MEMORANDUM

SUBJECT: Revision to approved plans for construction of a boat dock  
at 4301 Michaels Cove.  
File # SP-92-0006DS

WE SPILLAR BOAT DOCKS REQUEST THE CHANGE OF  
BOAT DOCK DESIGN AT MIKE WELWOOD BOAT DOCK  
4301 MICHAEL'S COVE.

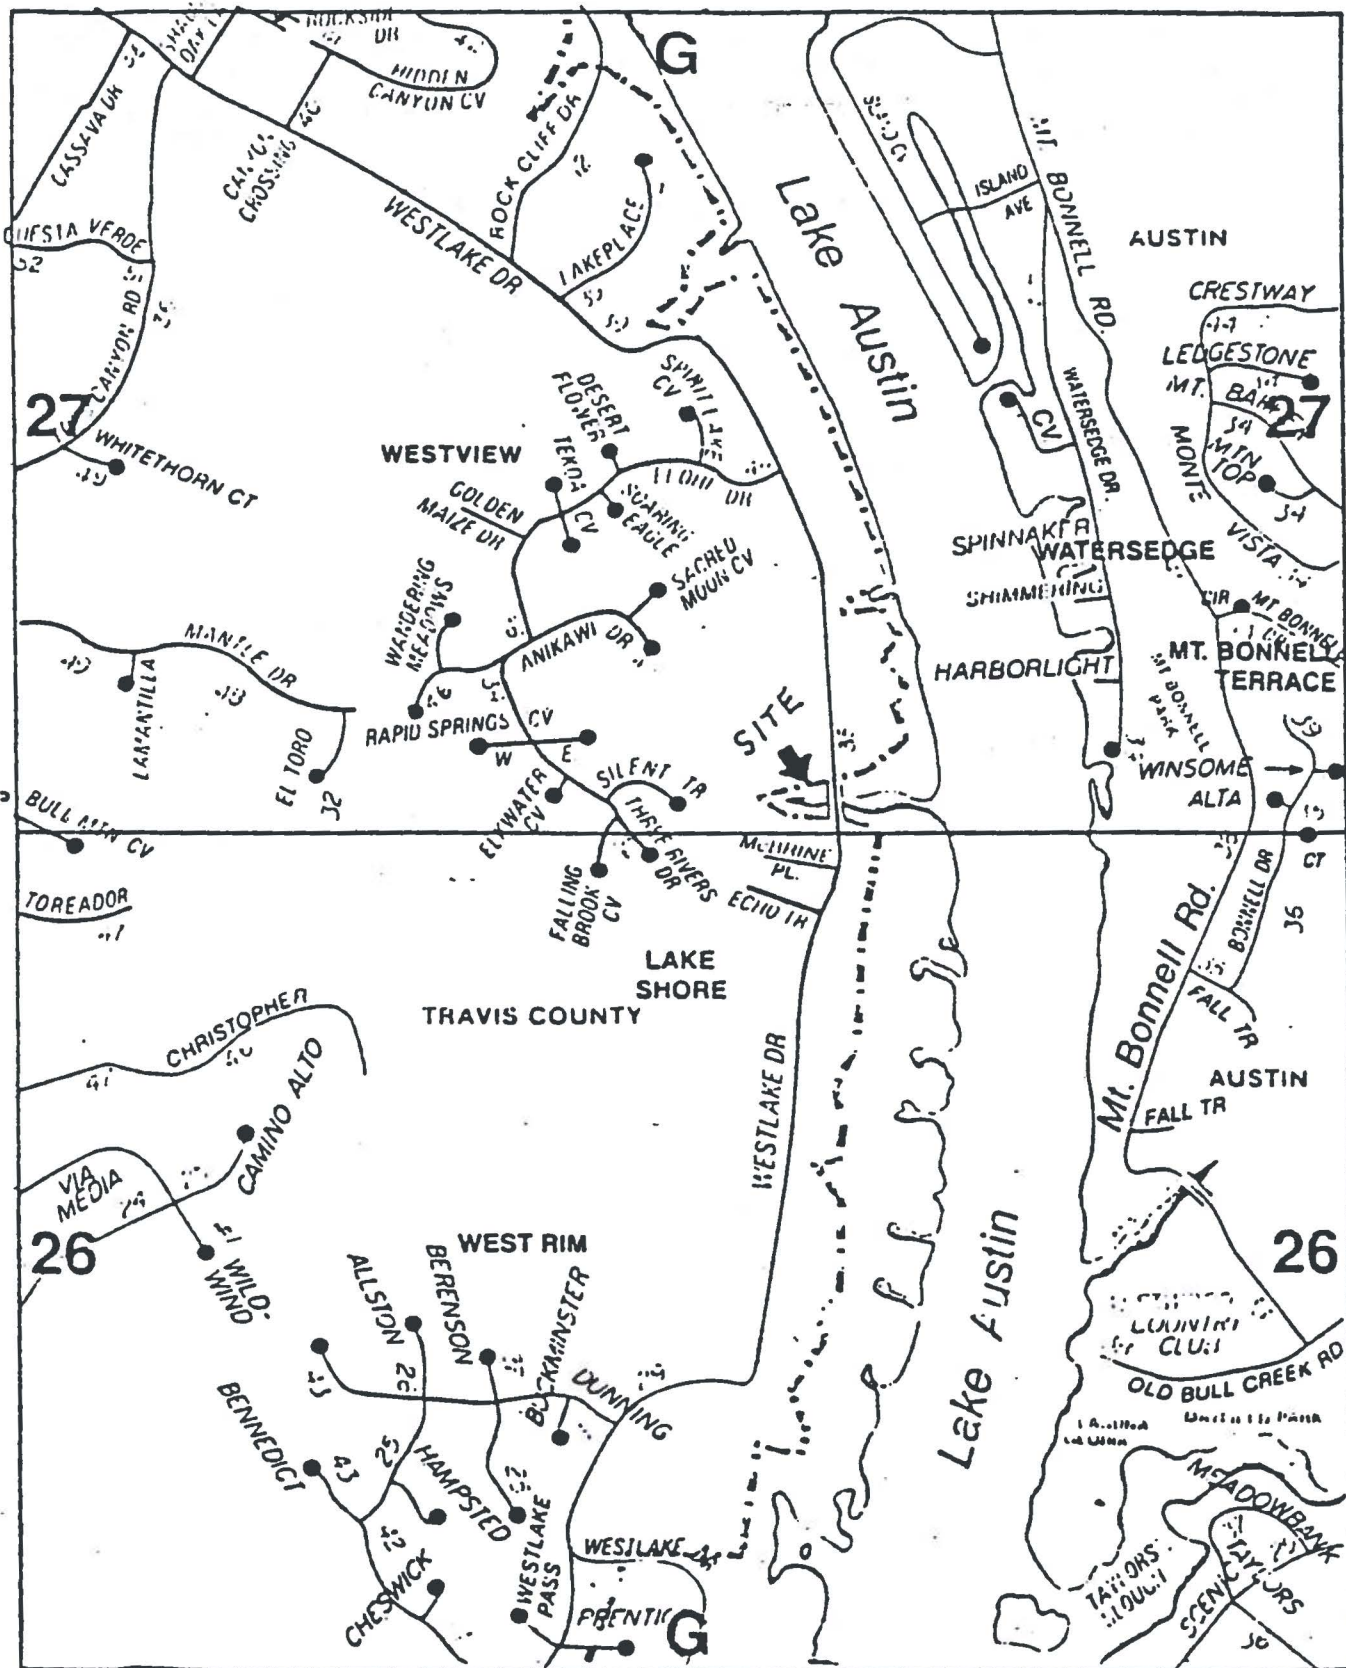
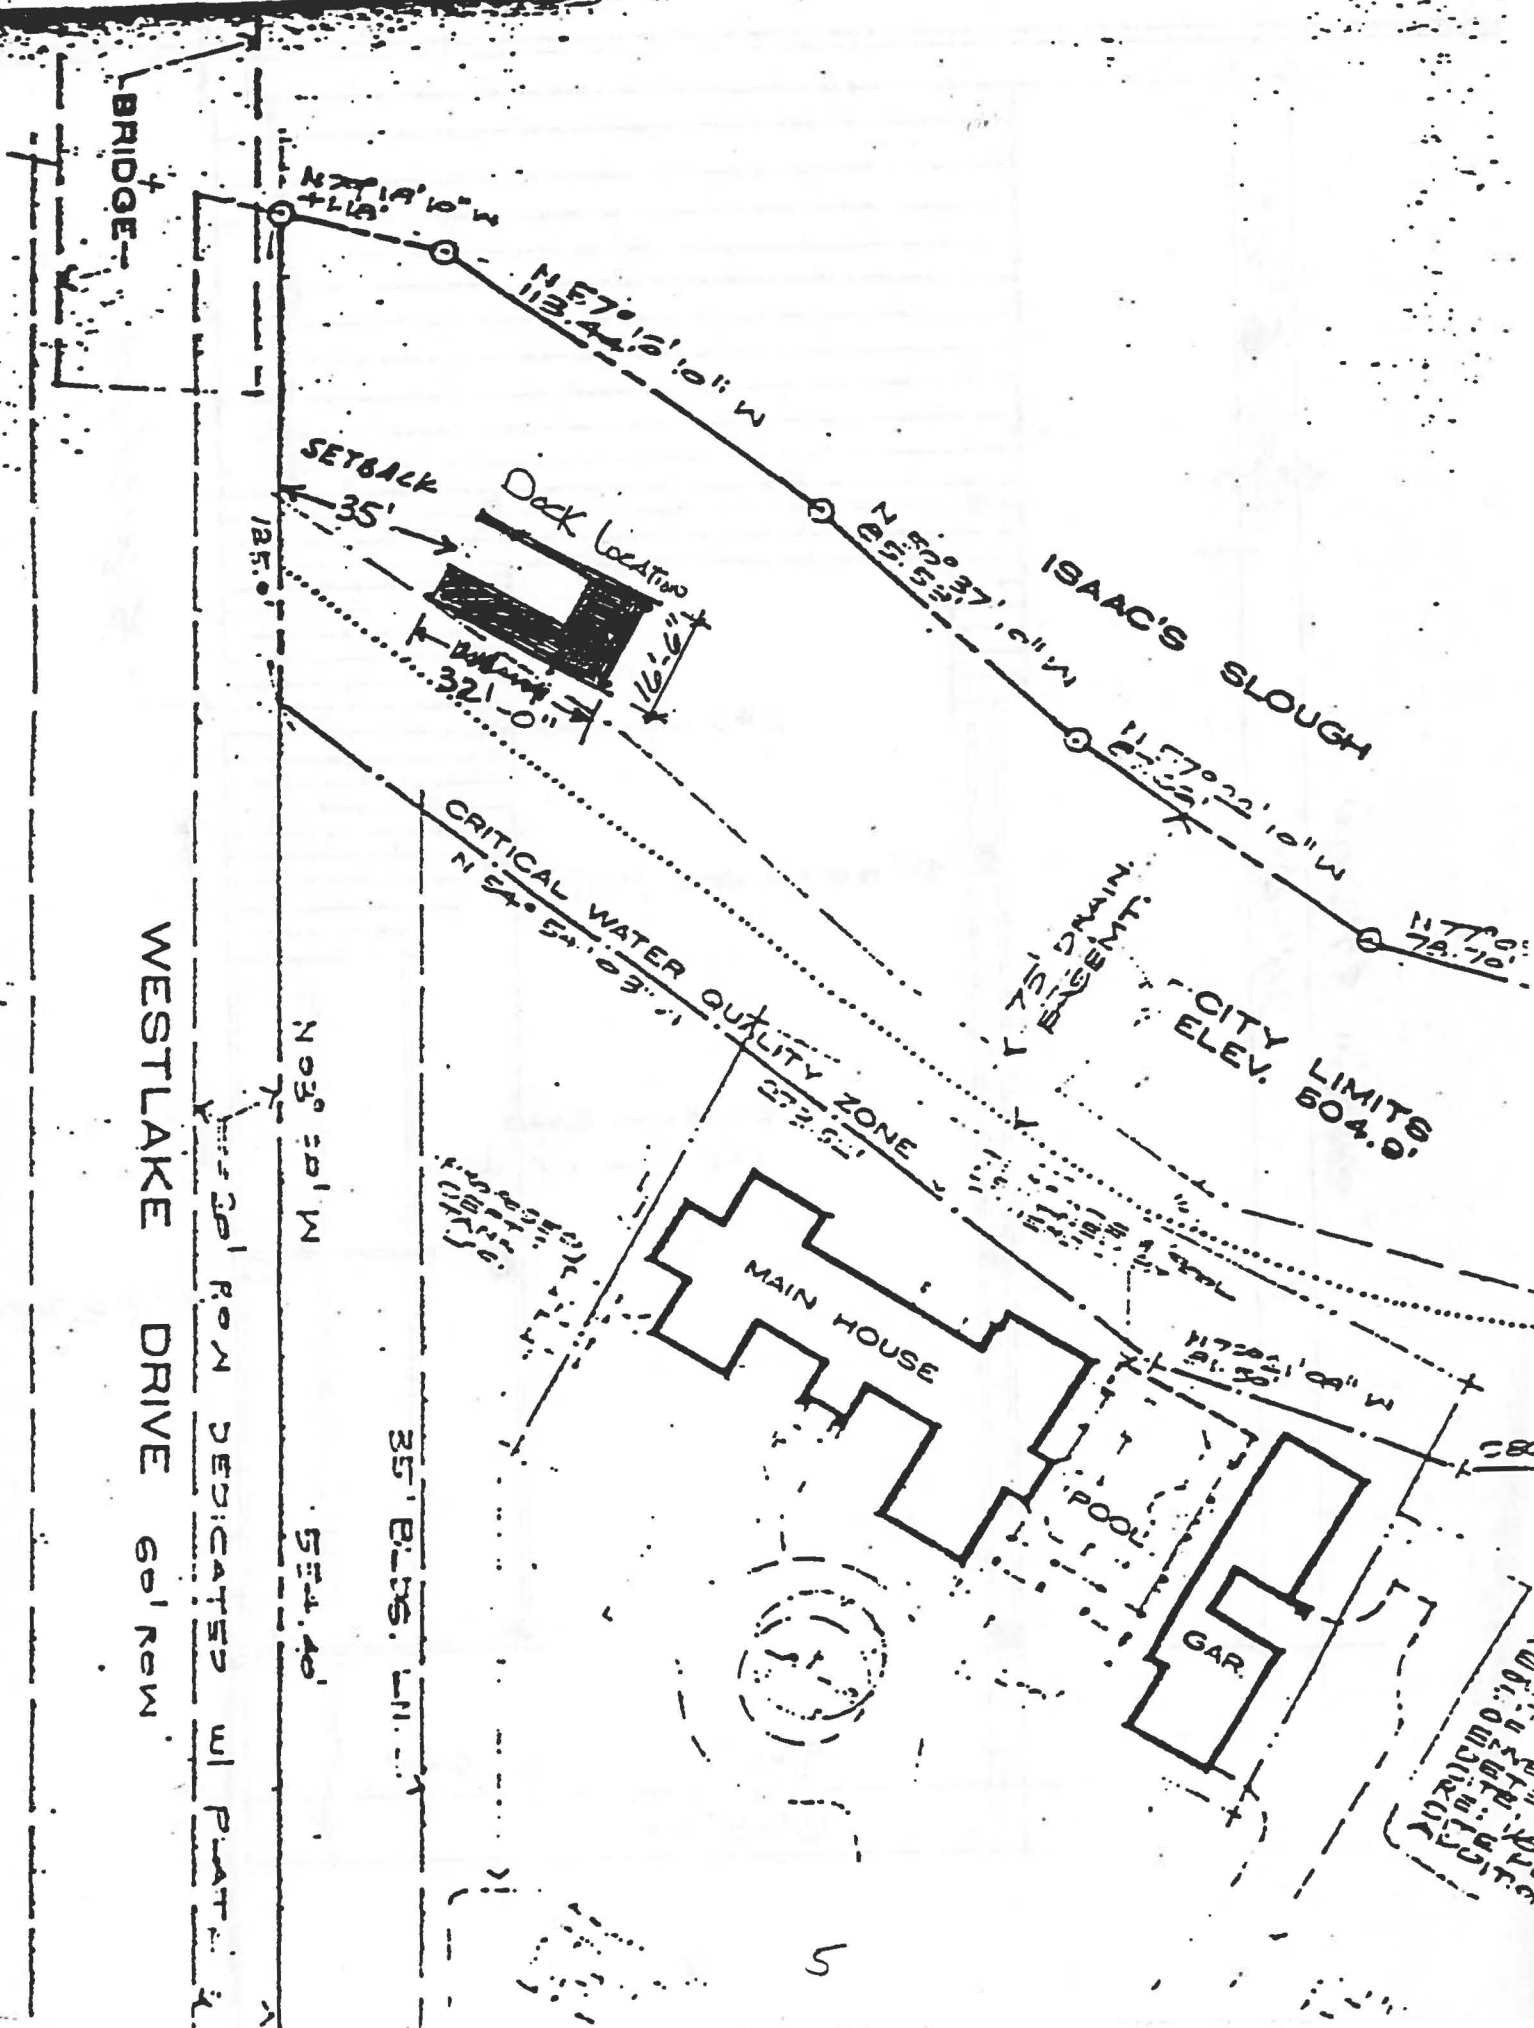
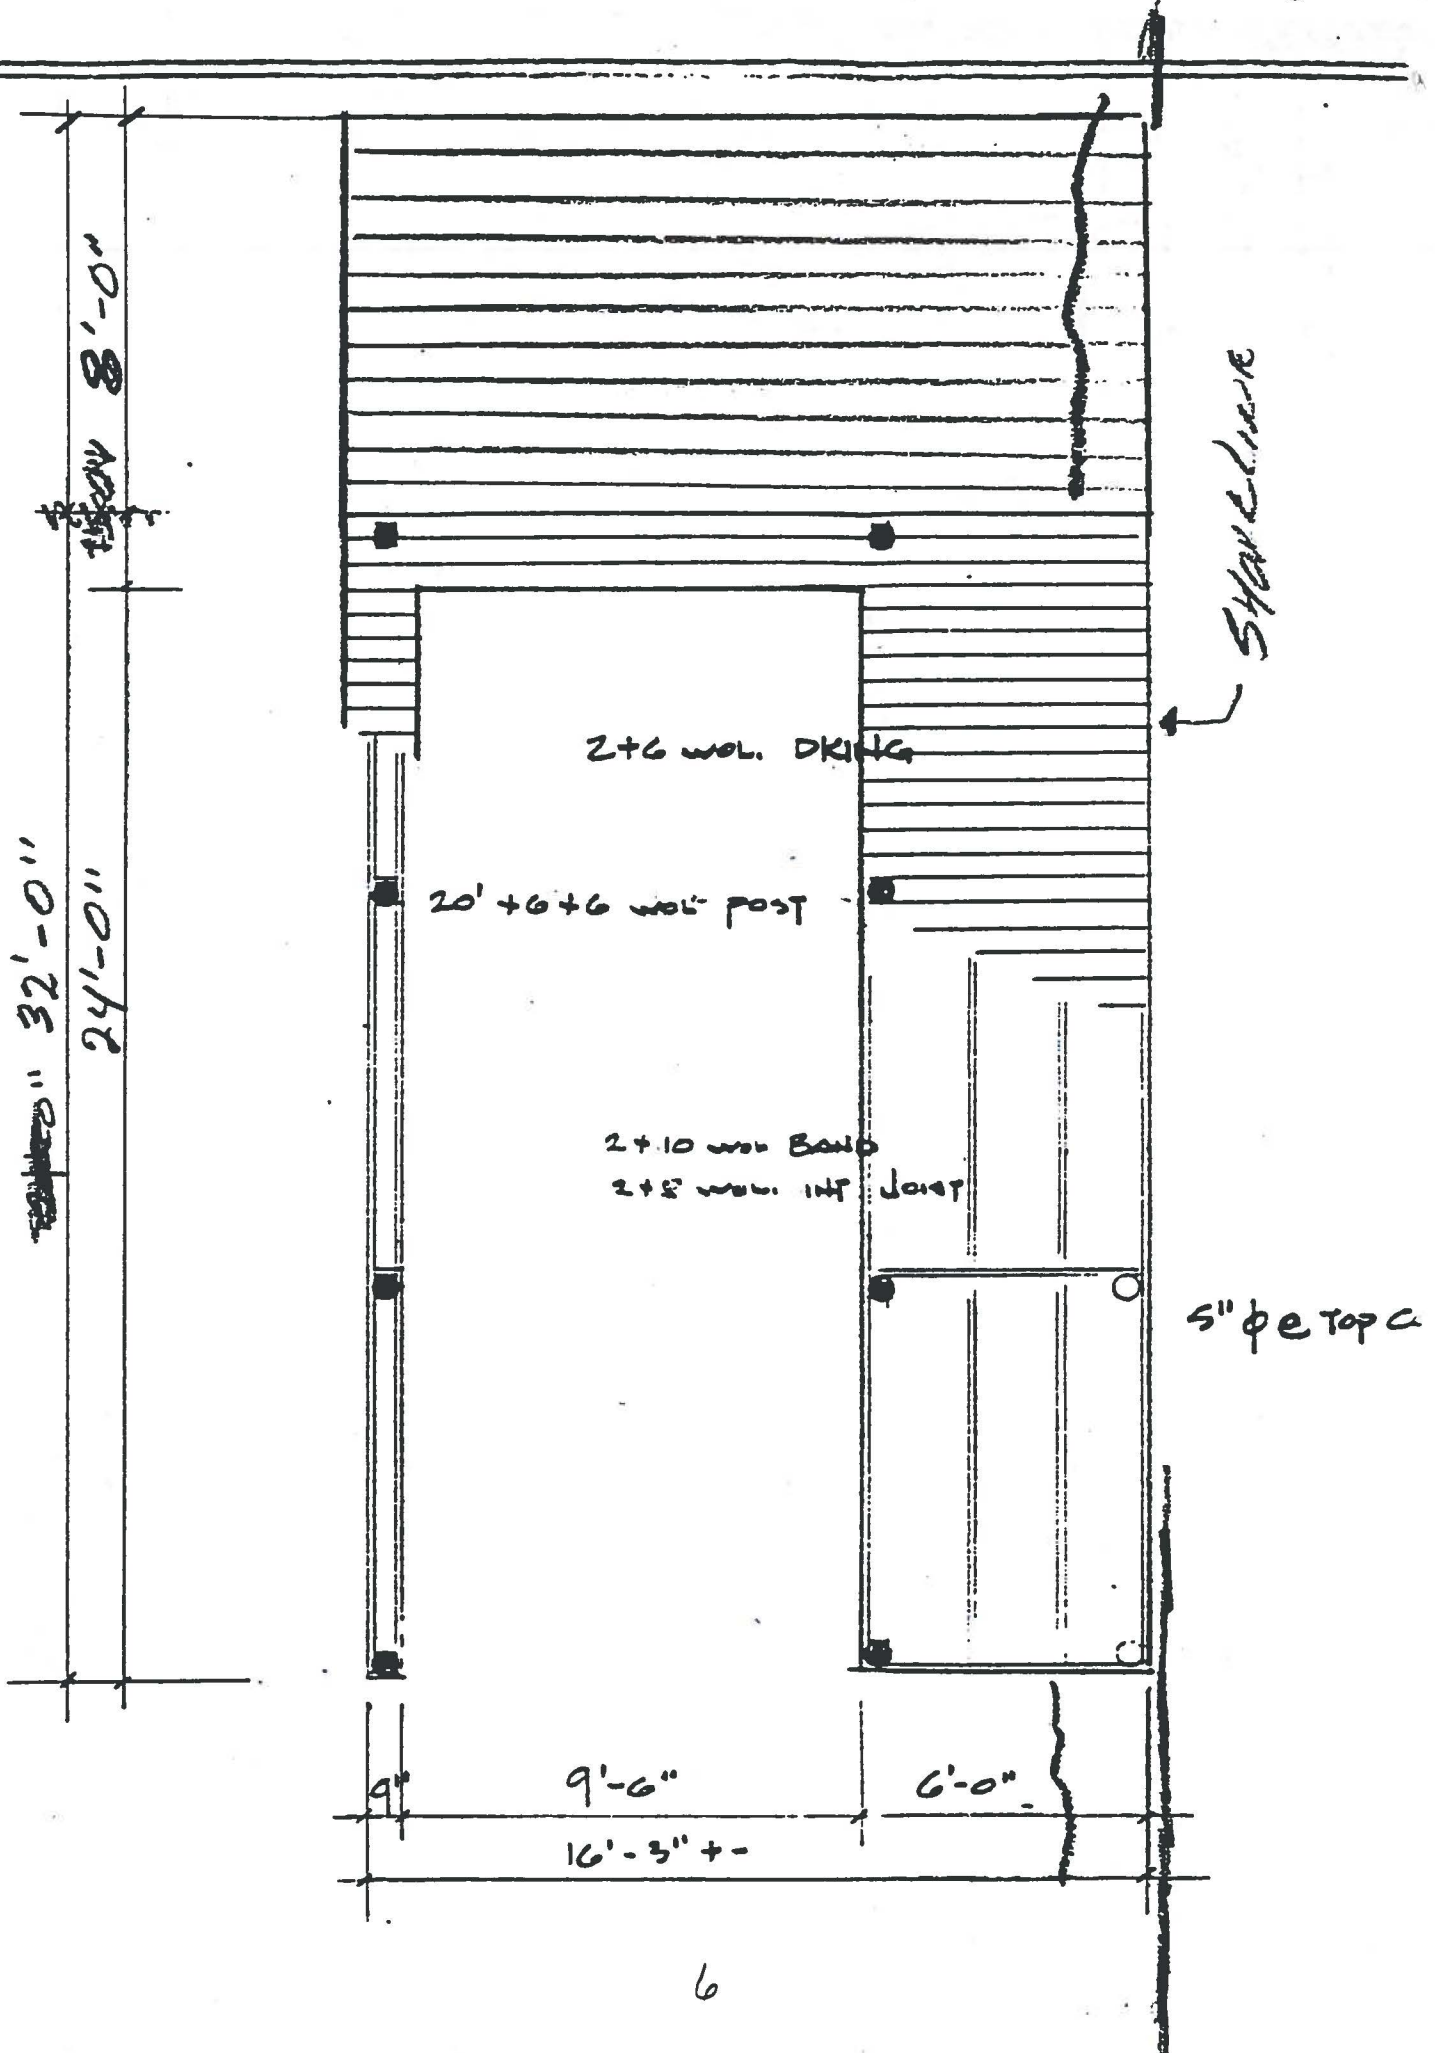
The revised plans propose to place the boat dock parallel to the shoreline, extending only 16'6" into Isaacs Slough, instead of perpendicular to the shoreline. The piers will be constructed of CCA treated timber instead of tubular steel.

DOCK TO BE 24' LONG X 16'-6" WIDE.

RATHER THAN 27' X 30'.

PIER TO BE CCA RATHER THAN STEEL.

DOCK LOCATION TO BE APPROX SAME.
